Remsenburg

Suite #216
ORIGINAL
Brochure

JOB NAME: UNIT 216 HMP (STANDARD)

KITCHEN FLOOR PLAN

STANDARD
* KITCHEN *
LAYOUT

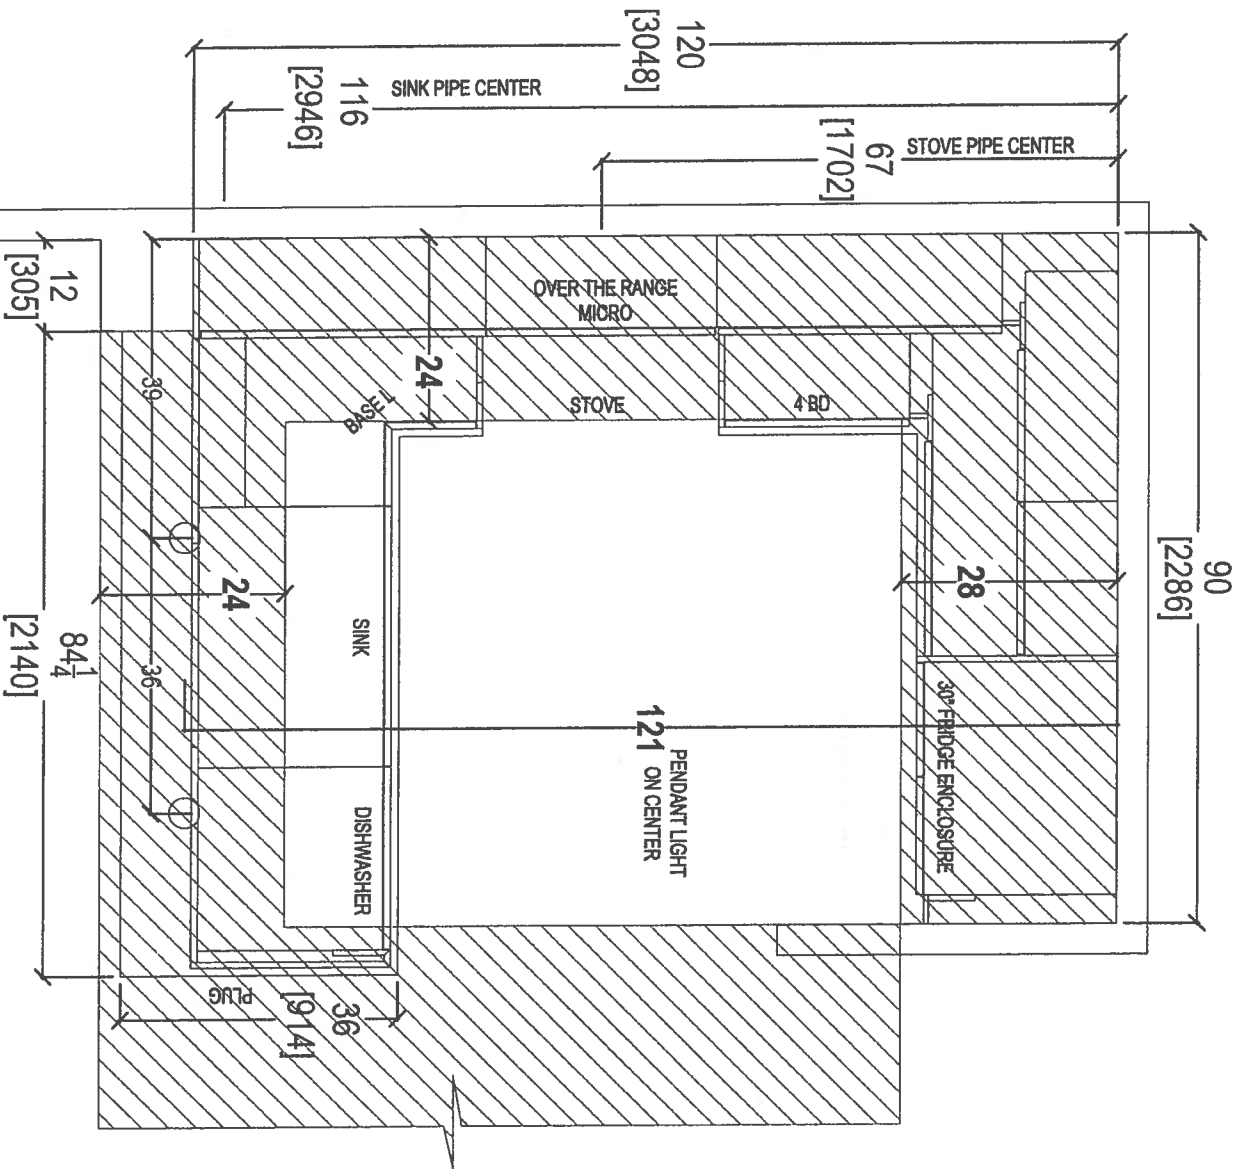
6" WALL BEHIND W/D
ELIMINATE JOG AT FRIDGE WALL

- (P) = PLUG, PENINSULA
- (2x) = PENDANT LIGHTS OVER PENINSULA
- Kitchen LAYOUT with STD Appliance PACKAGE
- BPT Kitchen LAYOUT w/ 1ST UPG Appliance PACKAGE
- 67" stove PIPE CENTER
- 116" SINK PIPE CENTER
